# Access Compliance Report

## Public Rights-of-Way

Intersection ID: 45240	Main Street: BEGONIA_DR	Cross Street: BLAZE_MANOR_LN	Location: SE
ADA ID: 6171B6075548	Ramp Type: PerpDiag	Initial Pass/Fail: Fail	Overall Compliance: No
Severity Score: 22.5			
Codes/Mitigation Info/Possible Solution		Field Measurements/Component Compliance

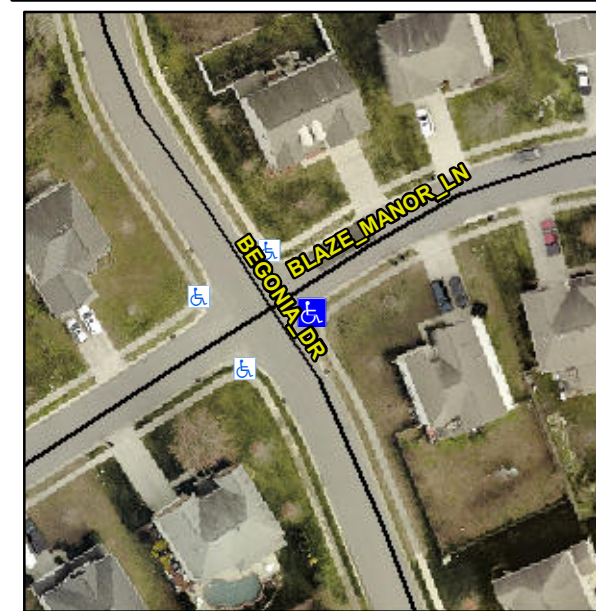
**Remove & Replace Curb Ramp With Two New Directional Ramps or Equivalent.**

**Not Found, R304.5.1, R304.2.2, R304.5.3**
